STAFF REPORT

Subject: Two Appeals of Development Review Approval for Aircraft Hangars
Case File No. APPEAL-001-26 Sky Harbour Barnes et. al.
Case File No. APPEAL-002-26 Sky Harbour Richmond et. al.
Underlying Case File No. DR-044-25 Sky Harbour Hangars

OVERALL SITE PLAN

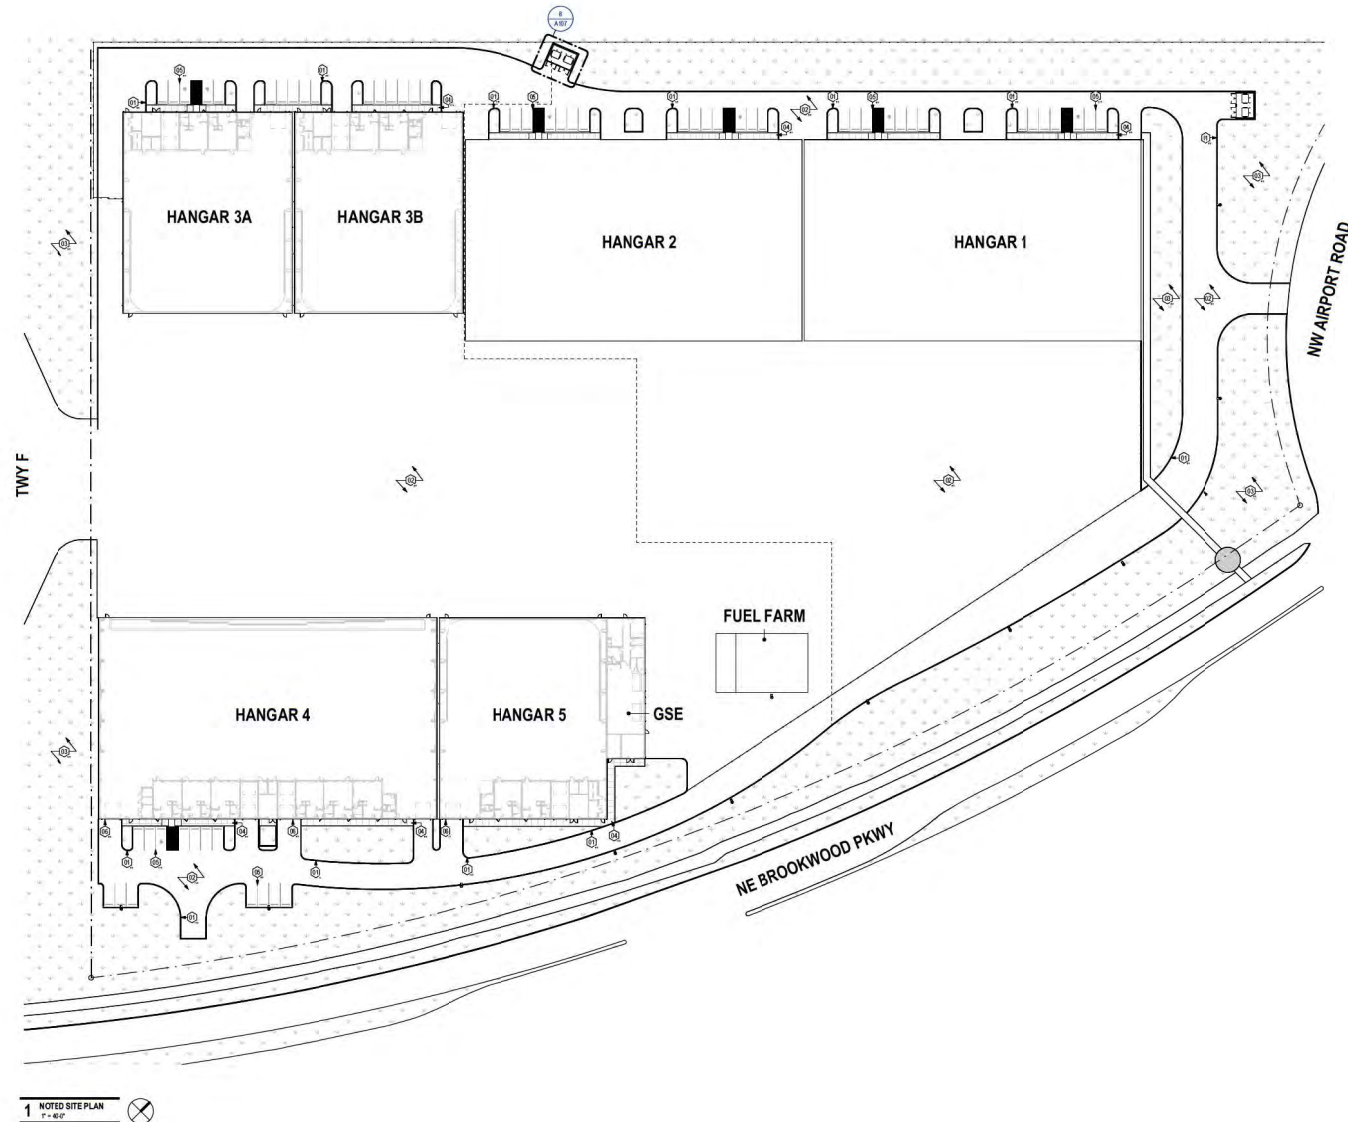
Following the April 8 hearing, the applicant submitted a revised proposal that eliminated every Major Adjustment. The mechanism was a change to the lease. Sky Harbour and the Port of Portland agreed to extend the western boundary of the leasehold by 23.5 feet,

No tax lot was added. The leasehold expansion occurred entirely within Tax Lot 1550. The proposed use did not change. The proposed use and street, lotting and parking layouts did not change. The revision moved the development westward within the same leasehold, farther from NE Brookwood Parkway and farther from the properties whose owners received notice. Total building area decreased, anticipated aircraft decreased, and effective building height decreased. The building count changed because one previously proposed hangar was divided into two smaller buildings, not because a new building was added. Every requested deviation from the code was eliminated.
